Access Compliance Report

Public Rights-of-Way

Intersection ID: 18350	Main Street: PROVIDENCE_RD	Cross Street: SHARON_LN	Location: S
ADA ID: 01848997A66D	Ramp Type: Perp	Initial Pass/Fail: Fail	Overall Compliance: No
Codes/Mitigation Info/Possible Solution			Severity Score: 10
			Field Measurements/Component Compliance

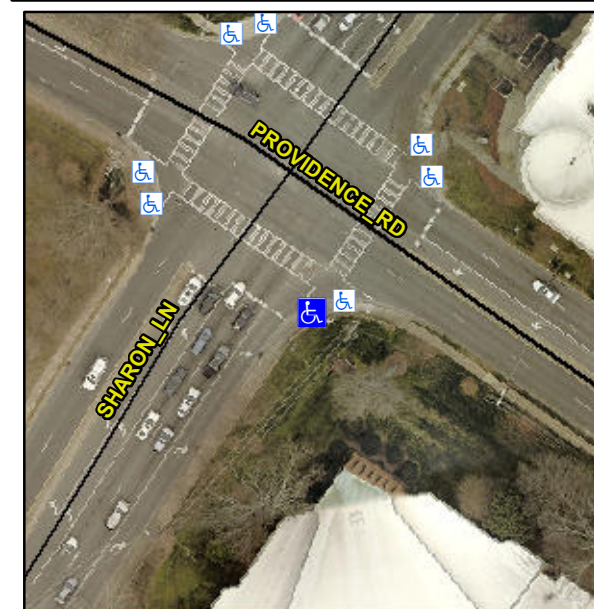
Not Found, R304.5.1, R304.5.3

Compliance	Description	Data	Compliance	Description	Data
N/A	Ramp Length (in)	82.0	Yes	Ramp Slope (%)	6.9
No	Ramp Width (in)	41.0	No	Ramp XSlope (%)	2.2
N/A	Flare Type LT	N/A	N/A	Flare Type RT	N/A
N/A	Flare Slope LT (%)	N/A	N/A	Flare Slope RT (%)	N/A
N/A	Flare Traversable LT?	N/A	N/A	Flare Traversable RT?	N/A
N/A	Landing Length (in)	N/A	N/A	DWS Provided?	N/A
N/A	Landing Width (in)	N/A	N/A	DWS Contrast?	N/A
N/A	Landing Slope (%)	N/A	N/A	DWS Length (in)	N/A
N/A	Landing X Slope (%)	N/A	N/A	DWS Full Width?	N/A
N/A	Landing Curb? (Y/N)	N/A	N/A	DWS Offset (in)	N/A
N/A	Shared Landing?	N/A			
N/A	Gutter Ponding?	N/A	N/A	Gutter Slope (%)	N/A
N/A	Gutter Lip Ht (in)	N/A	N/A	Gutter X Slope (%)	N/A
N/A	Painted X Walk1?	Yes	N/A	Painted X Walk2?	N/A
	X Walk 1 Direction	To NW		X Walk 2 Direction	N/A
N/A	X Walk 1 Width (in)	130.0	N/A	X Walk 2 Width (in)	N/A
	X Walk 1 Slope (%)	1.4		X Walk 2 Slope (%)	N/A
	X Walk 1 X Slope (%)	0.1		X Walk 2 X Slope (%)	N/A

Remove & Replace Entire Ramp.
